**** ADDENDUM NO. 1 to REQUEST FOR BIDS ****

**SYLVIAN STREET INFRASTRUCTURE AND STREETScape IMPROVEMENTS
BID NO. 2021-0011**

CITY OF CENTRAL FALLS

GENERAL PLAN NO. 1

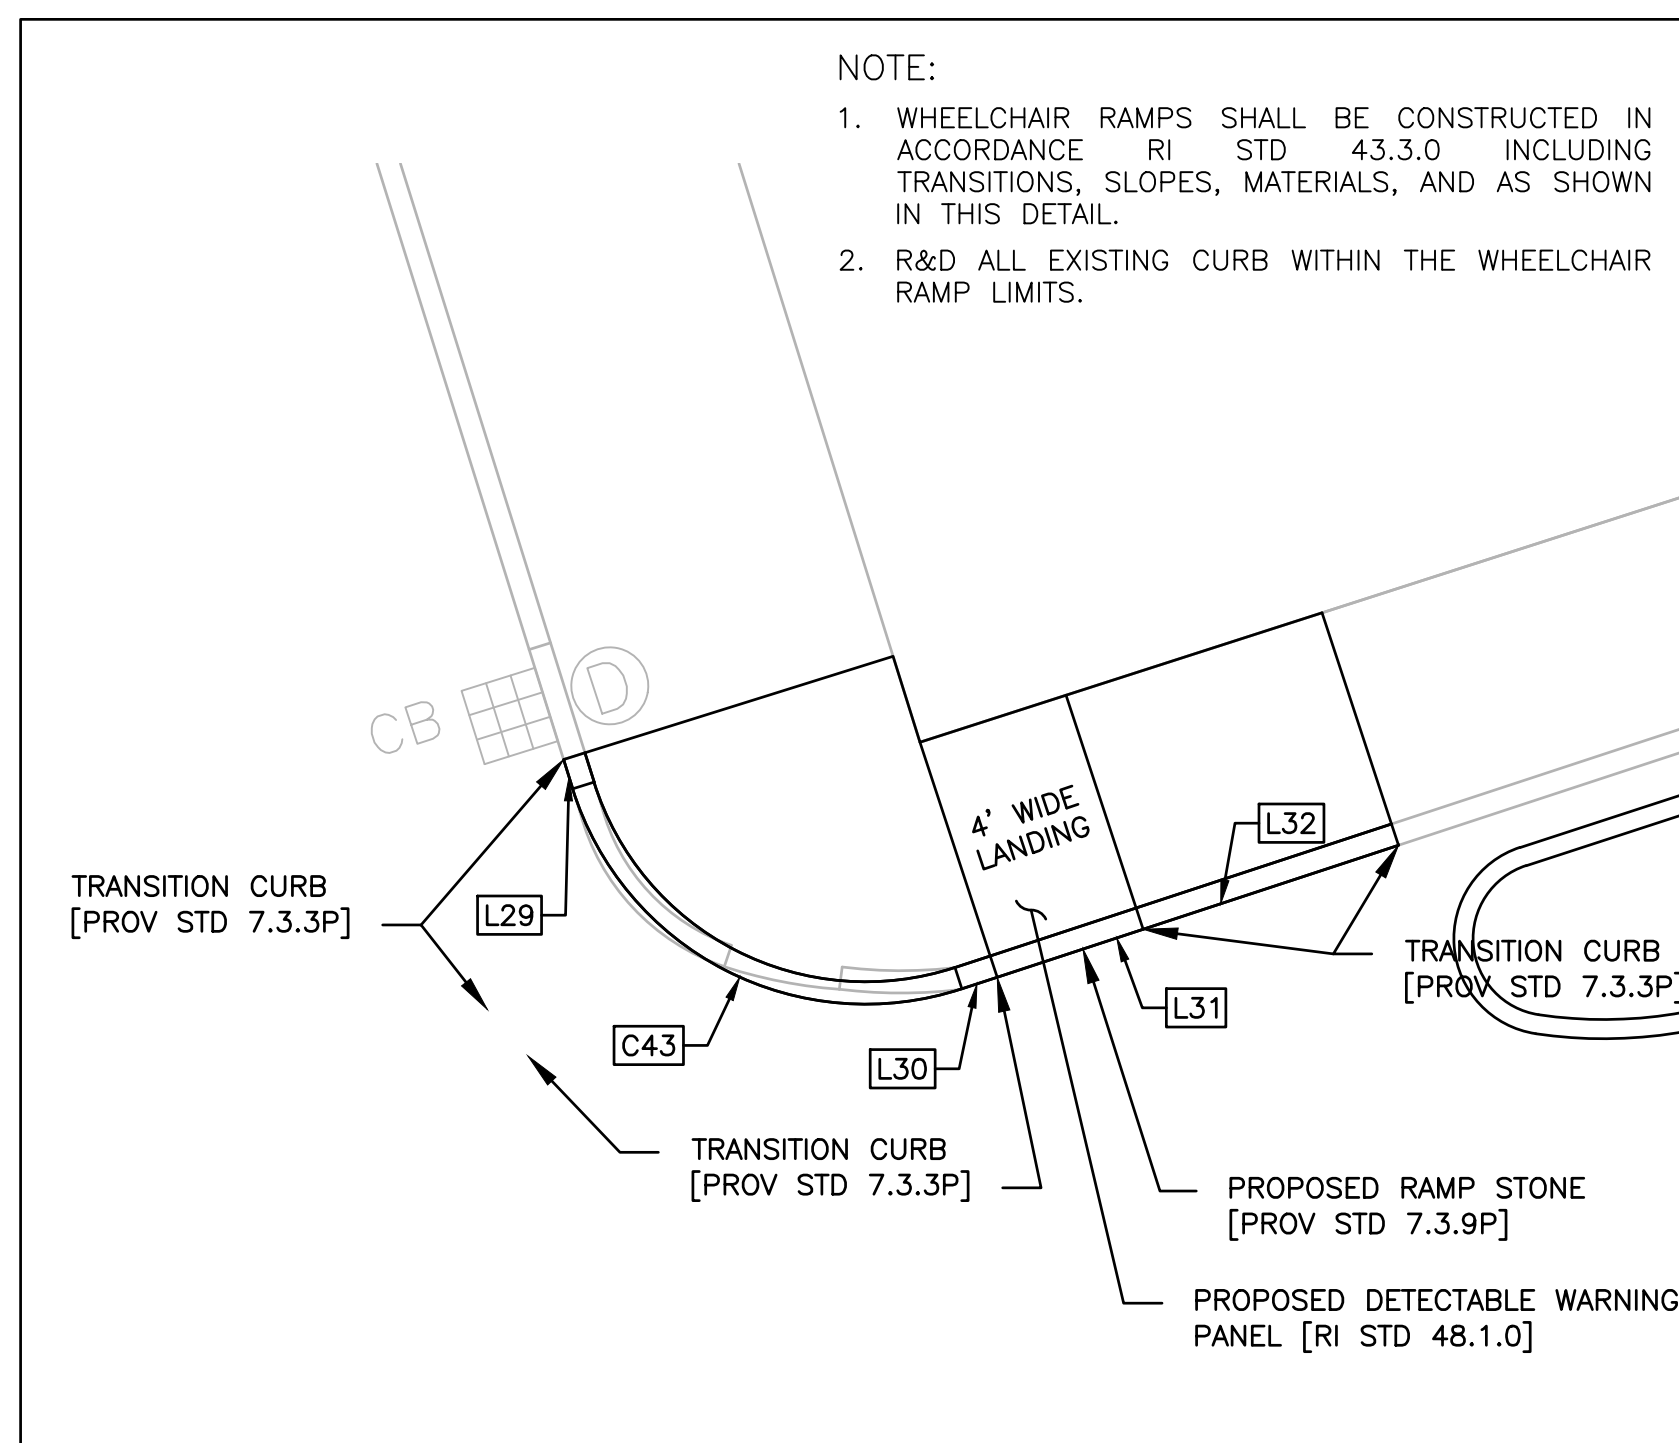
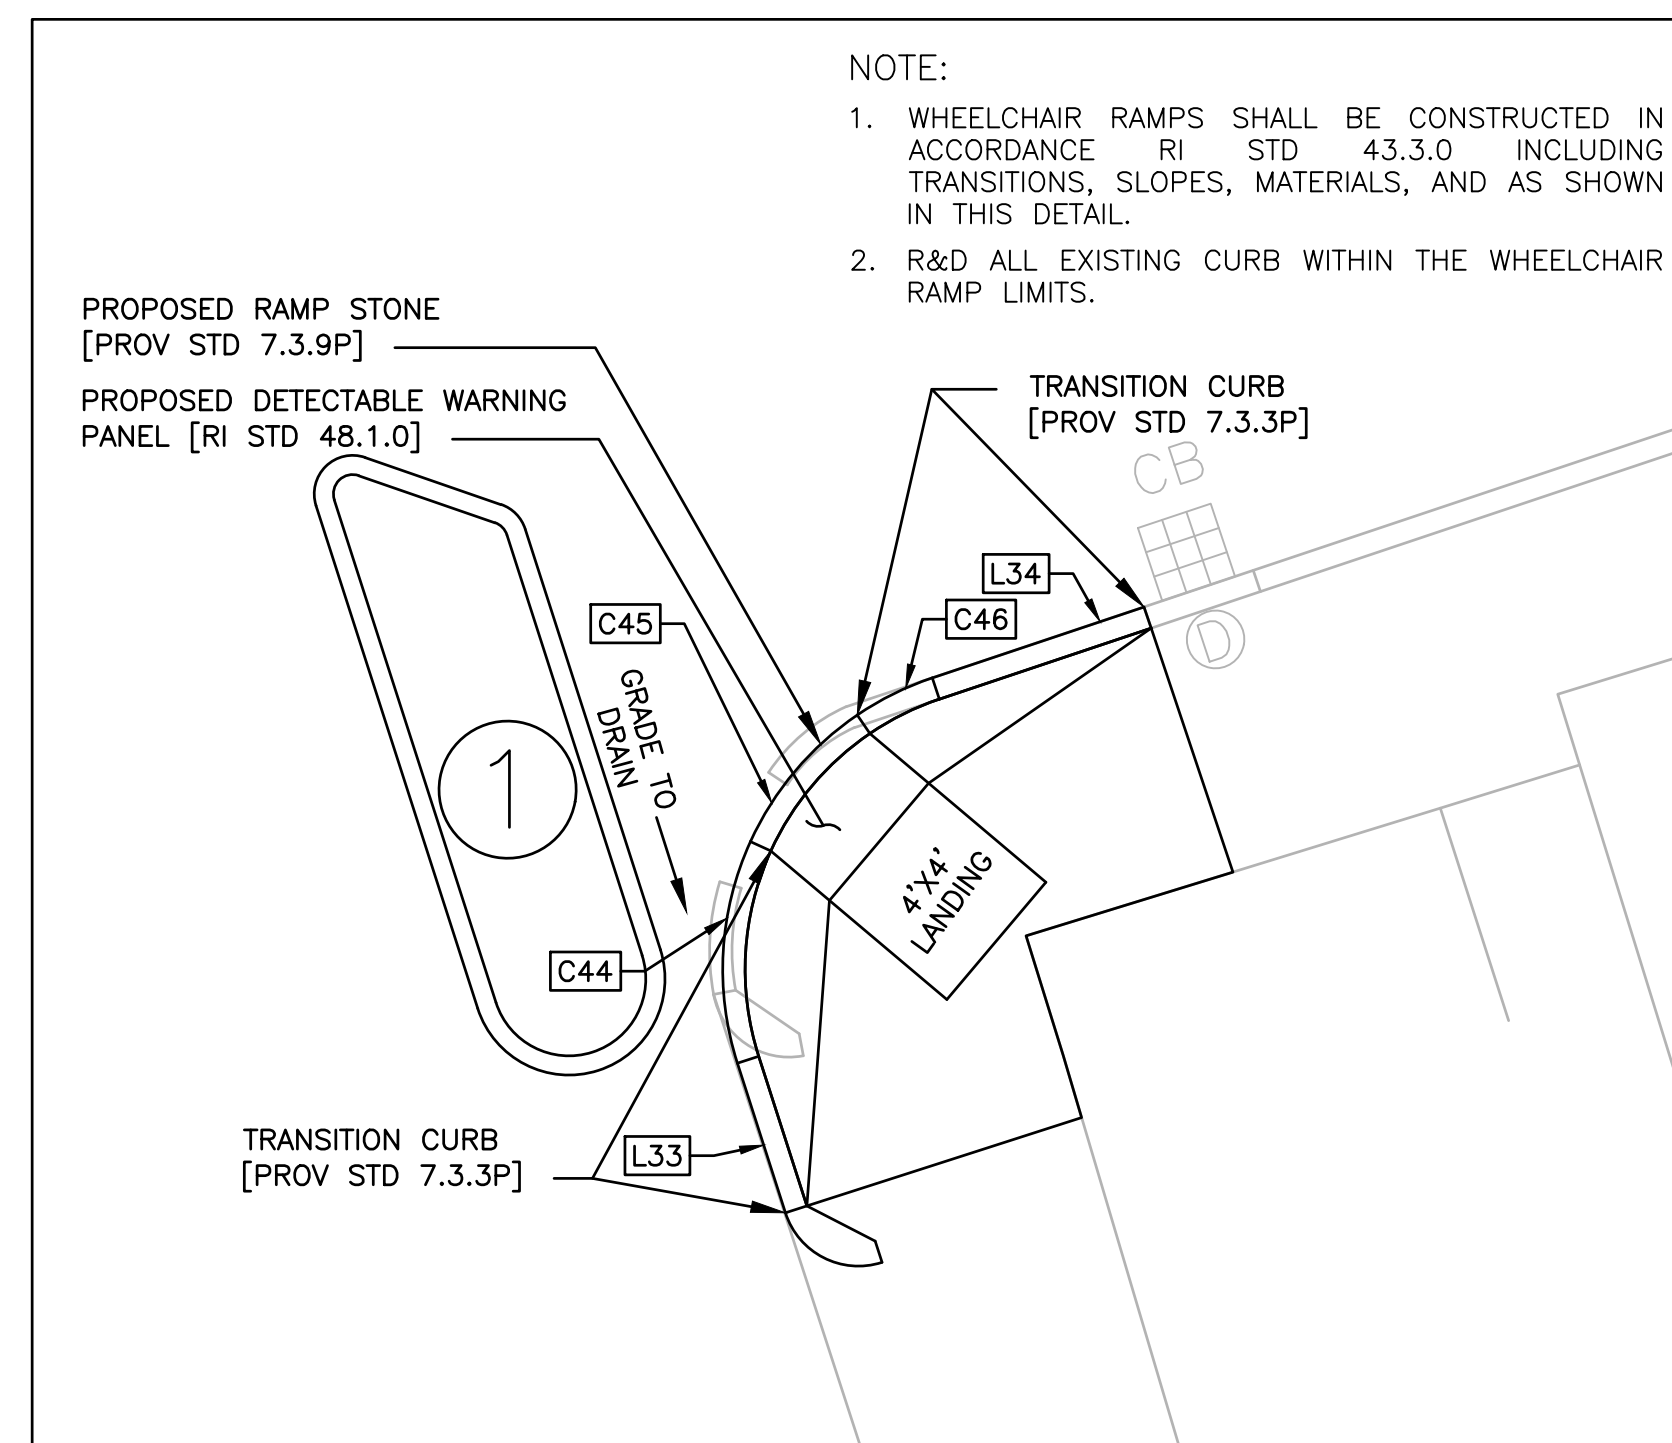
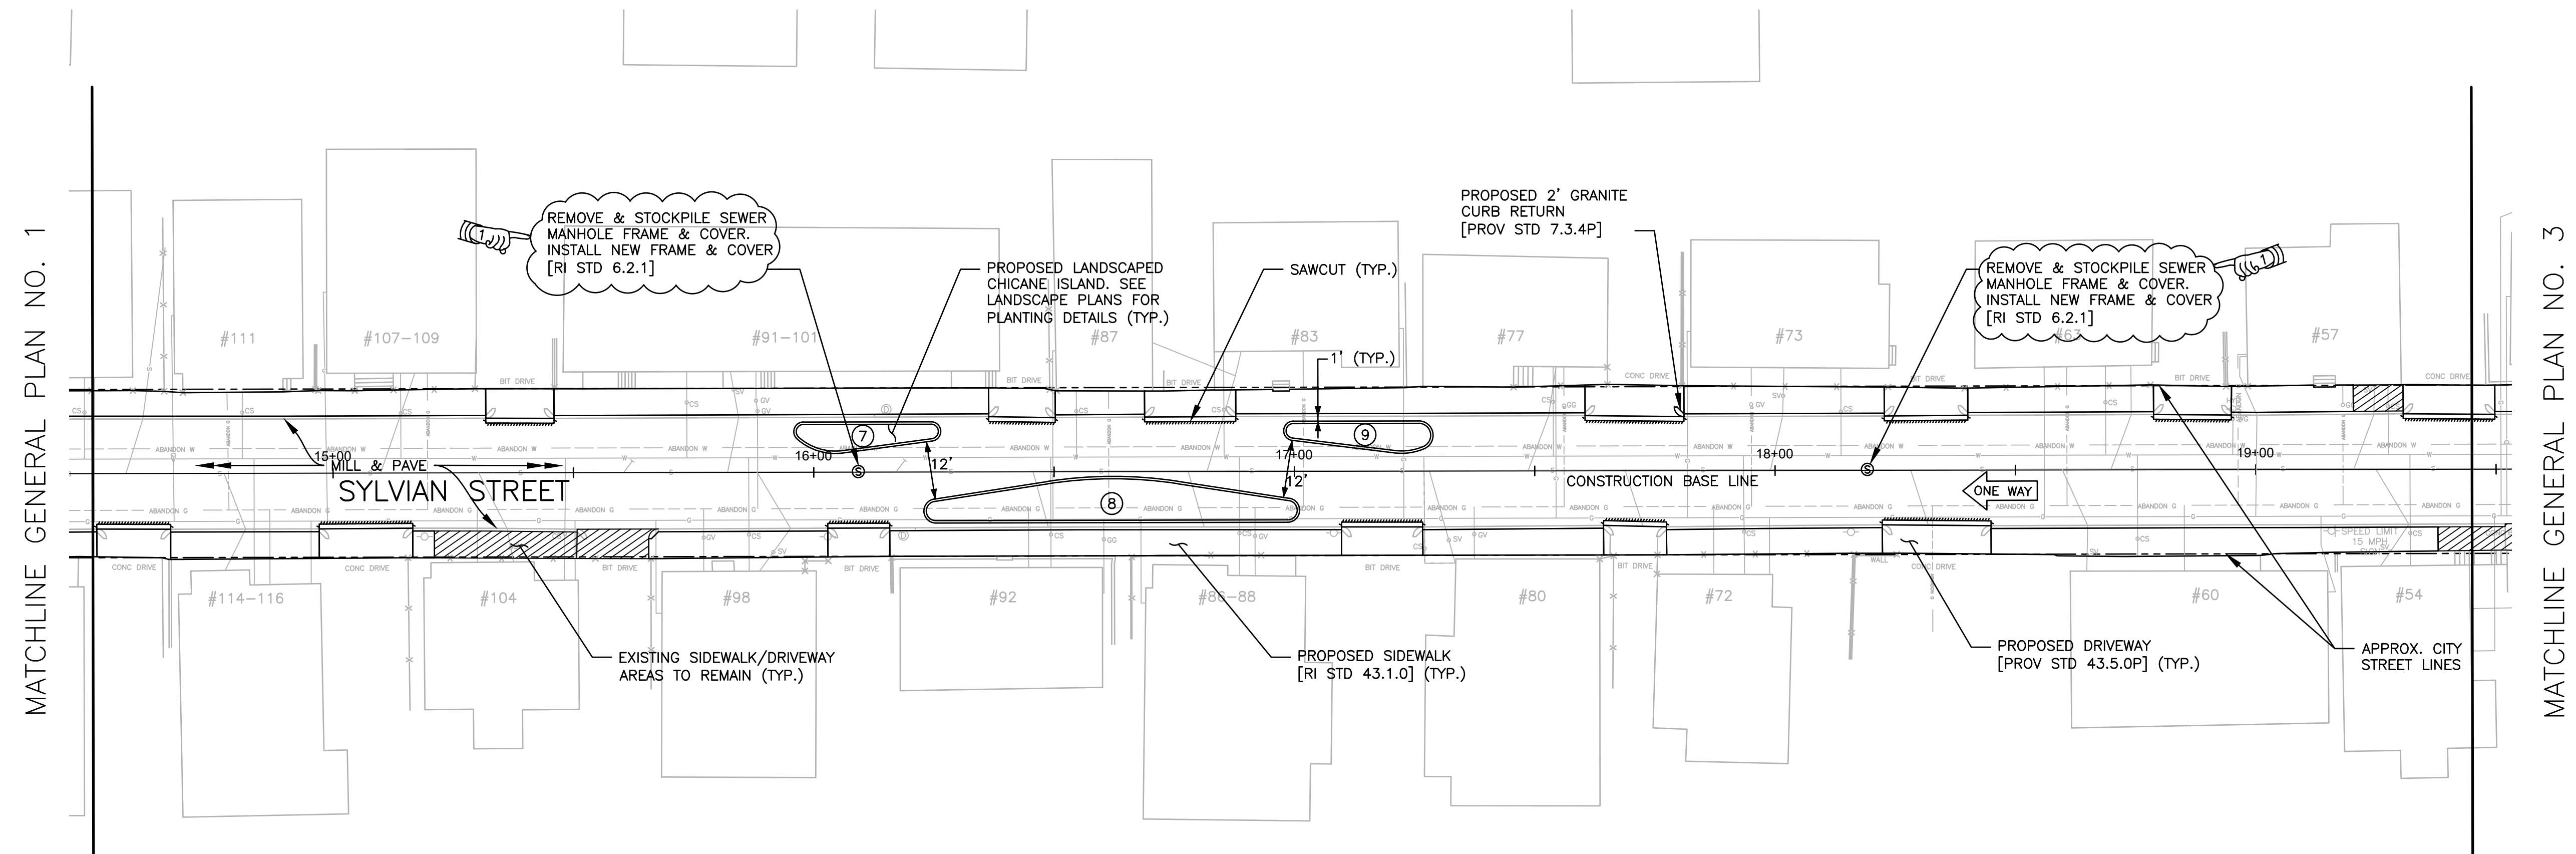
- a. Delete sheets 6, 7, and 8, General Plan No. 1, General Plan No. 2, and General Plan No. 3, respectively, and replace them with sheets 6, 7, and 8 labeled as ADDENDUM NO.1 in the lower right corner and R-1 in the upper right corner of the page (Revision No.1 dated 9/1/21 is indicated in the Revisions Table). The amended pages are attached to this Addendum No. 1.

The callouts “REMOVE & STOCKPILE SEWER MANHOLE COVER & GRATE. INSTALL NEW [RI STD 6.1.1]” have been changed to “REMOVE & STOCKPILE SEWER MANHOLE FRAME & COVER. INSTALL NEW FRAME & COVER [RI STD 6.2.1]”
